Amendments/Additional Information

LUDDINGTON NYM/2016/0614/FL, CW

NEWBIGGIN HIGH FARM COTTAGES REVISED LAYOUT

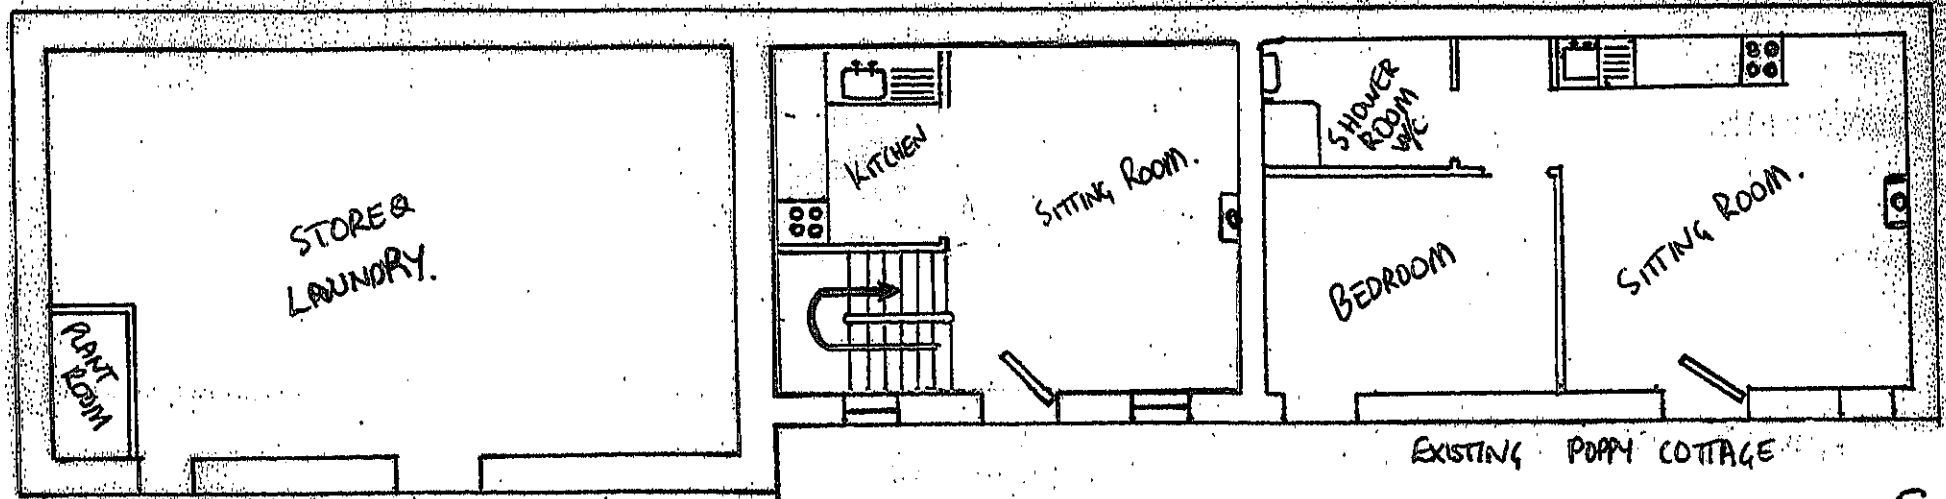
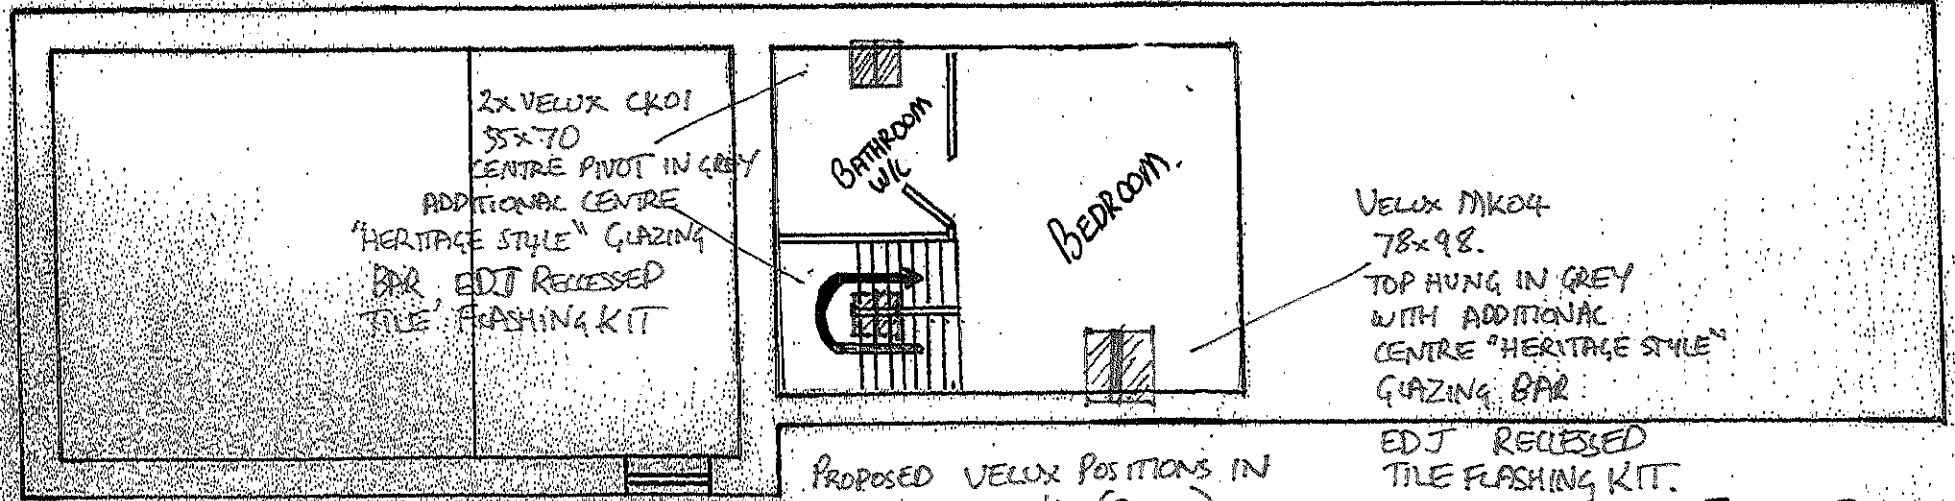
- Amended layout of buildings/outside areas
- Additional background information
- Amended design
- Revised access arrangements
- Change of description of proposed development
- Change in site boundaries
- Other (as specified below) - Confirmation of rooflight sizes.

PROPOSED VELUX POSITIONS IN BLUE HATCHING. (3 OF.)

VELUX MK04 78x98. TOP HUNG IN GREY WITH ADDITIONAL CENTRE "HERITAGE STYLE" GLAZING BAR. EDJ RECESSED TILE FLASHING KIT.
